# Galong - MOD4 Kiln Coal Stockpile

Submissions Report

07 March 2023

Project No.: 0662616

**Conceptual MOD4 Layout**

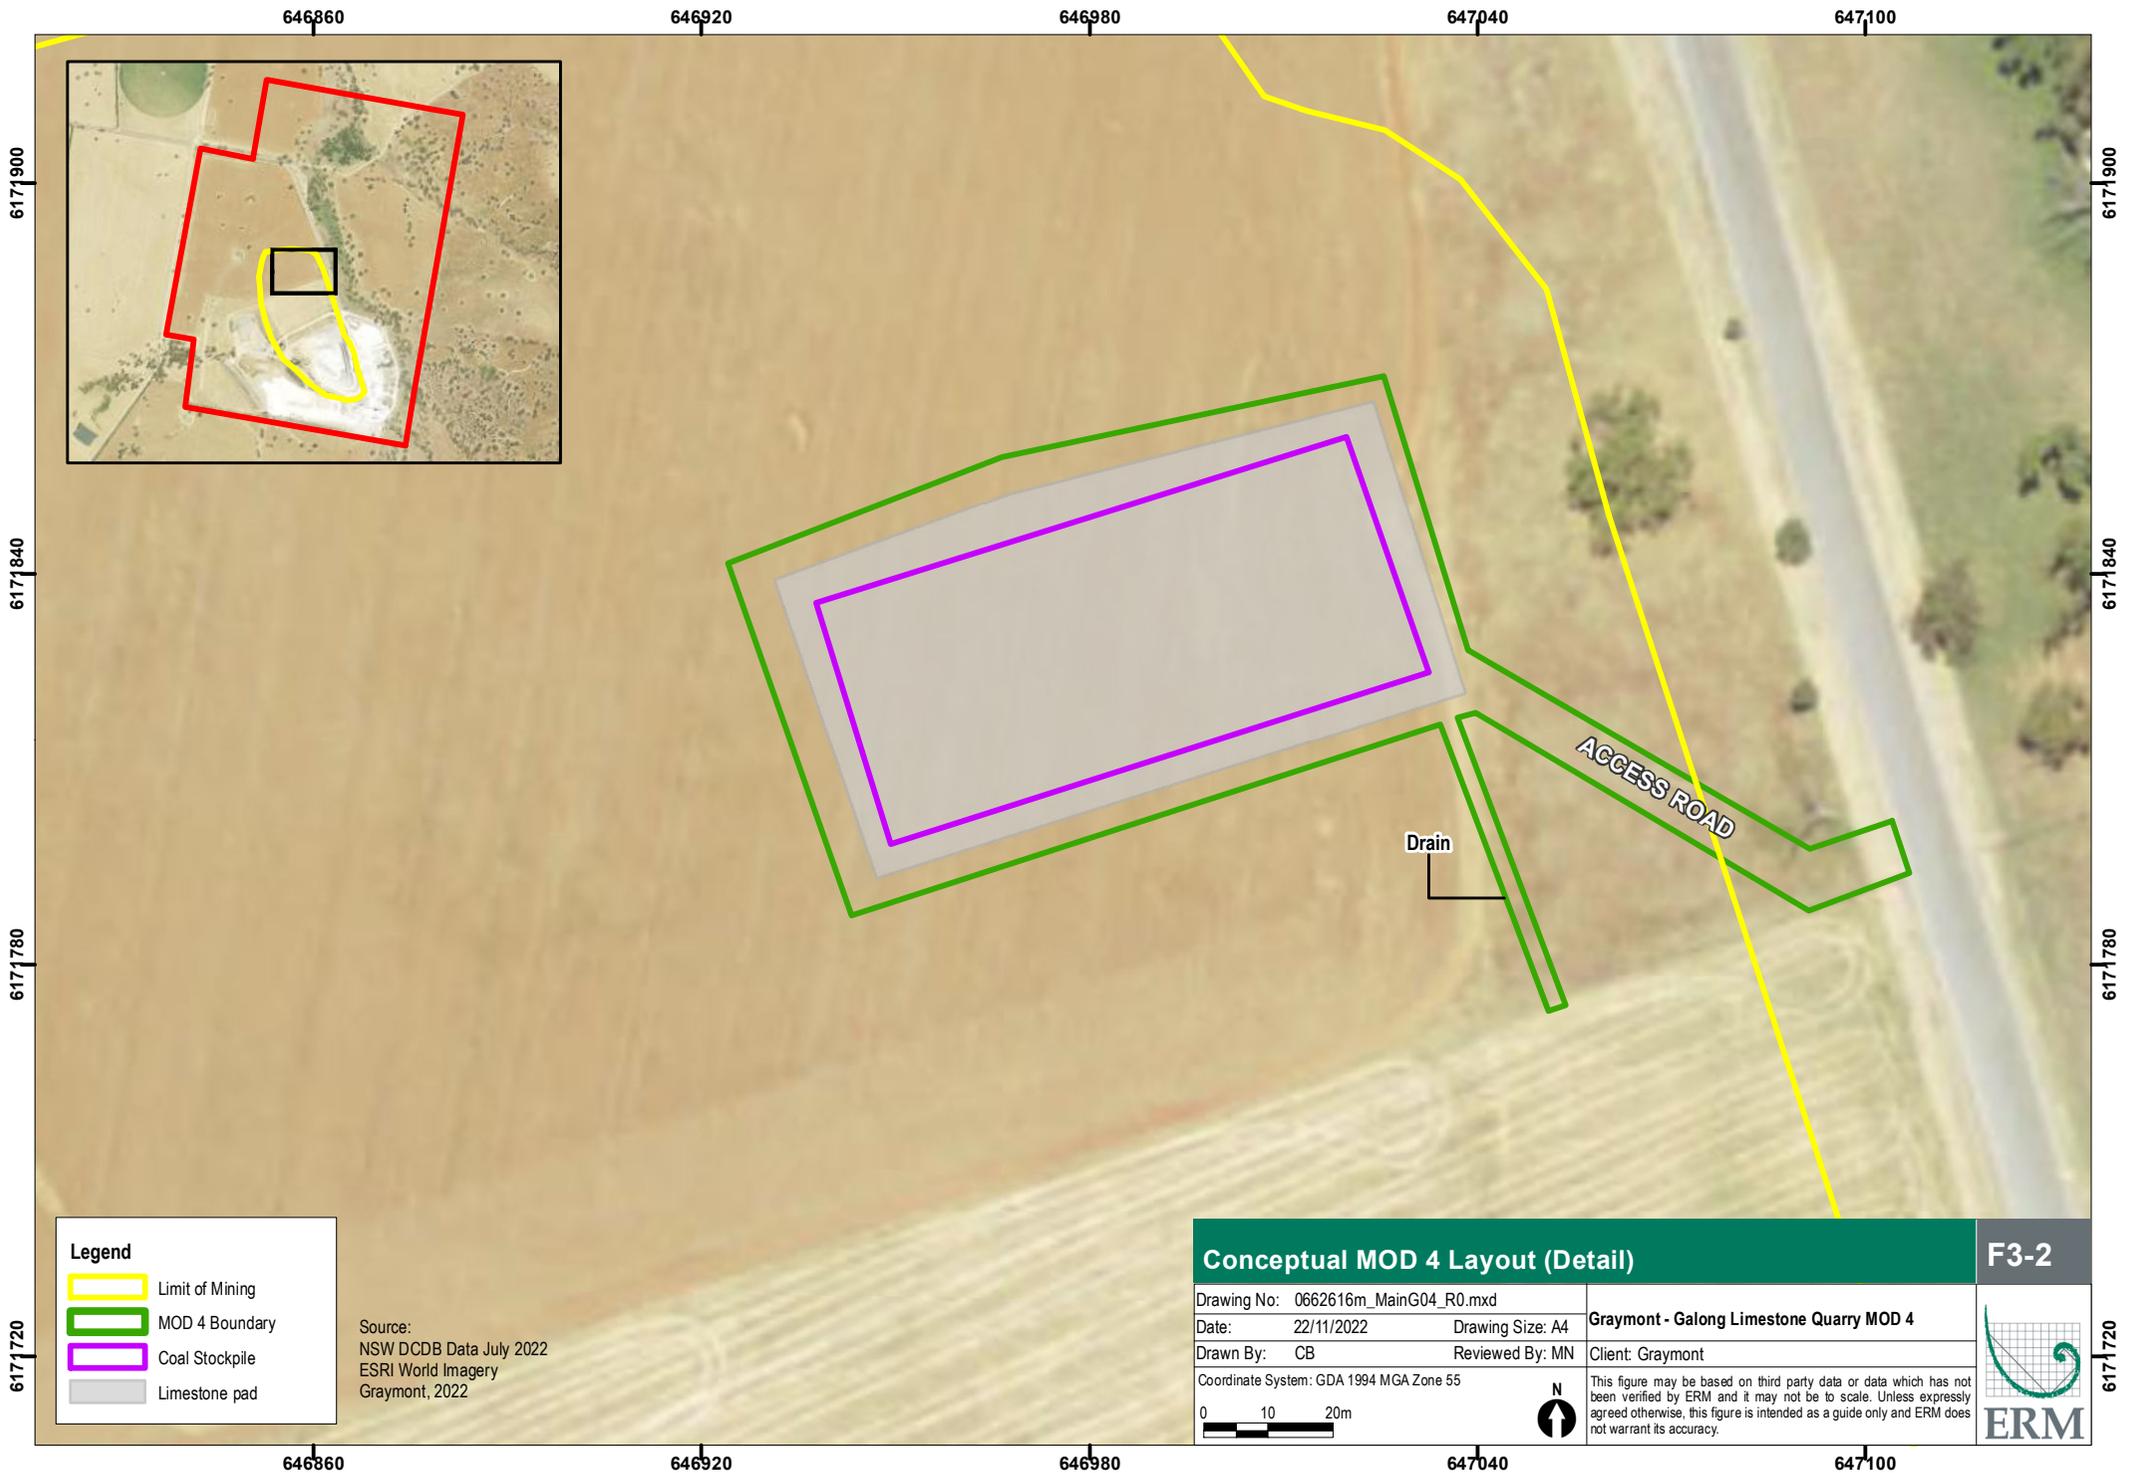
DPE_3	<p>Section 3.2 of the Modification Report states that the proposed stockpile would drain to the SW corner, whereas Figure 3.2 suggests that the stockpile drains to the SE corner. Please clarify this discrepancy.</p>	<p>Email correspondence via Applicant and DPE on 13 February 2023 confirmed that the storage pad area will drain to the south-east corner, as shown in Figure 3.2 of the Modification Report. The reference to drainage to the south-west corner in section 3.2 was in error.</p>	<p>Appendix B, Email Correspondence</p>
DPE_4	<p>Section 6.4.1 of the Modification Report states that a dozer is proposed to be used for stockpile compaction, however a dozer has not been included as a noise or emissions source in the noise or air quality assessments. Please provide additional information on the potential noise and air quality impacts of dozer use if this is to be used on site.</p>	<p><u>Air Quality</u> Table 4-2 (Estimated dust emissions from proposed activities and comparison to previous emissions) of the Air Quality Assessment (Appendix C) has been updated to consider the emission factor for the front end loader (FEL) / dozer working on the coal stockpile. Although this update increased the estimated FEL / dozer emission, the overall dust emissions from MOD4 activities remain 1% of the site-wide emissions and are still considered non-material in terms of dust emissions.</p> <p><u>Noise</u> The Noise Assessment (Appendix E), has been updated to consider dozer as noise source, with an assumed Sound Power level of <math>L_{eq(15 \text{ min})}</math> 116 dB(A). The assessment concluded that the addition of a dozer presents a negligible increase in predicted noise levels.</p>	<p>Appendix D, Updated Air Quality Assessment</p> <p>Appendix E, Updated Noise Assessment</p>

3. Section 3.2 of the Modification Report states that the proposed stockpile would drain to the SW corner, whereas Figure 3.2 suggests that the stockpile drains to the SE corner. Please clarify this discrepancy.

Regarding information request item (3), we confirm that the storage pad area will drain to the south-east corner, as shown in Figure 3.2 of the Modification Report. The reference to drainage to the south-west corner in section 3.2 is an error.

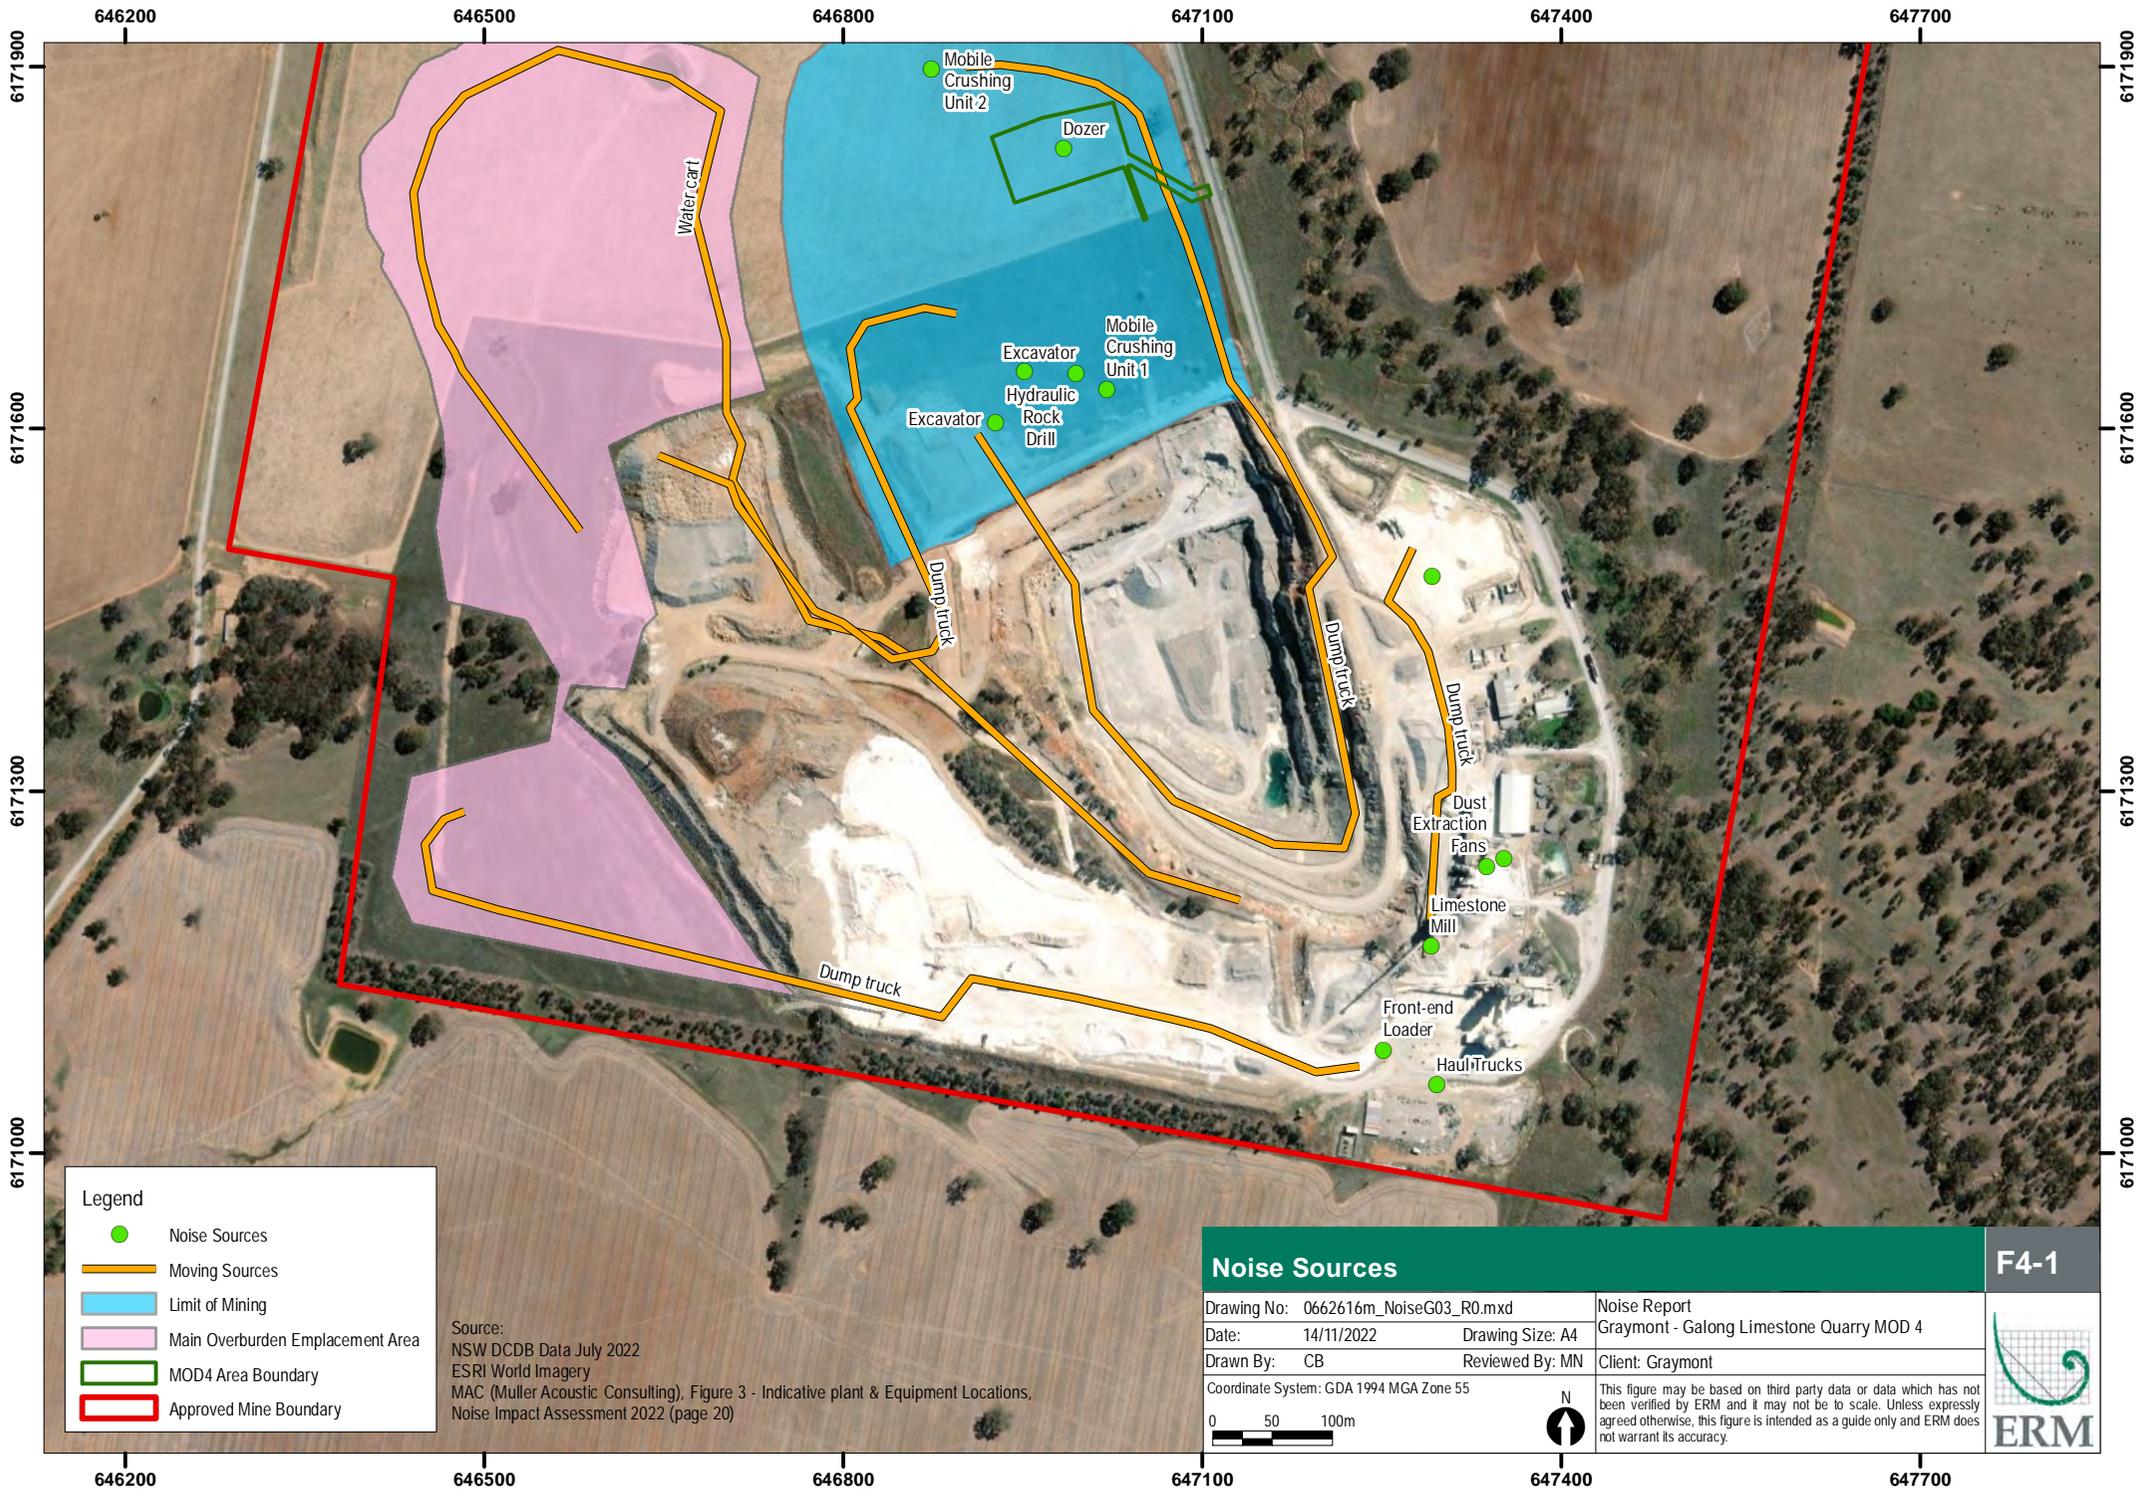
4. Section 6.4.1 of the Modification Report states that a dozer is proposed to be used for stockpile compaction, however a dozer has not been included as a noise or emissions source in the noise or air quality assessments. Please provide additional information on the potential noise and air quality impacts of dozer use if this is to be used on site.

In addition to the above-mentioned noise sources, a dozer in the MOD4 area has also been included in this assessment, with its assumed Sound Power level being L<sub>eq</sub>(15 min) 116 dB(A). The location of the dozer is shown in **Figure 4-1**.

The assumed dump truck routes to access the new stockpile for this modification are also shown in the figure.

**Figure 3: Intersection Locations**

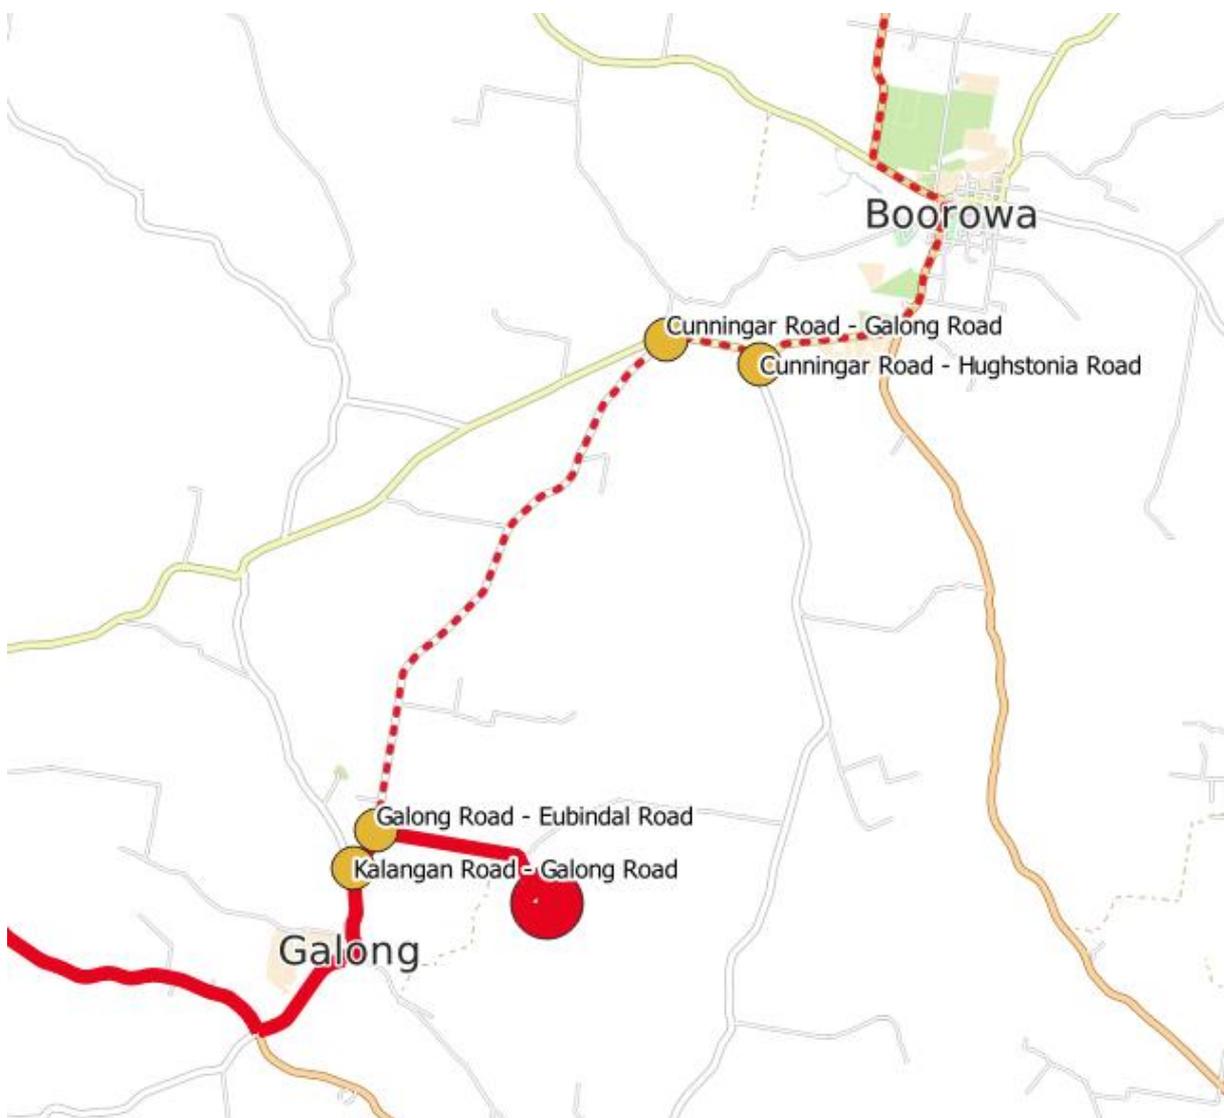
“The Traffic and Transport Assessment presented in the Modification Report provides an assessment of intersections that connect the haulage route to the State Road network. Please provide an assessment of the intersections along the haulage route that are located on the local road network”

There are intersections where the trucks would turn. These locations are shown in Figure 3.
